Opel Corsa-D - Front brake system

Model year 2007

Front brake system

Squeaking noises when braking

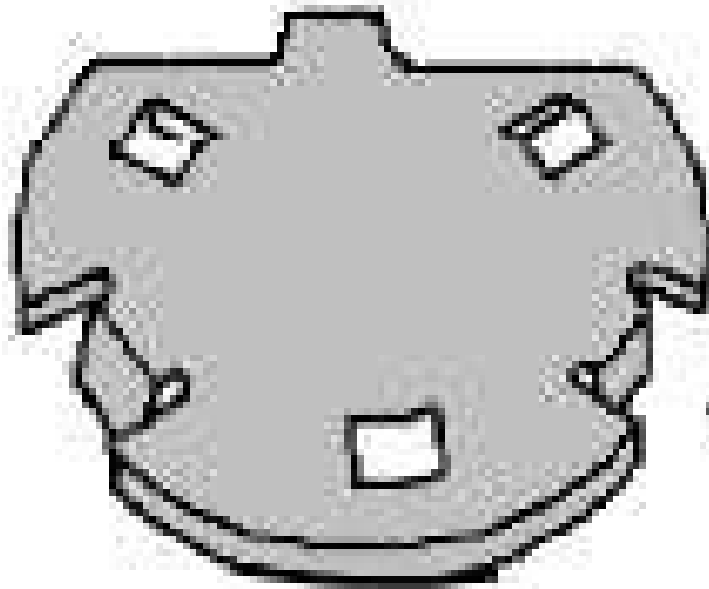
If the symptom specified above cannot be allocated to any detectable defect on the wheel brake, one possible cause of this is an insufficient decoupling between the brake pad and the brake caliper. For improving comfort, the vehicle manufacturers have installed so-called "Piston Caps" in the piston (A) of the brake calipers.

In case of a complaint, this must be checked and renewed where appropriate. On vehicles affected without "Piston Caps", these can be retrofitted.

These additional "Piston Caps" (B) have been introduced to the production from the following chassis numbers.

Spare part number "Piston Cap": Opel 93169307
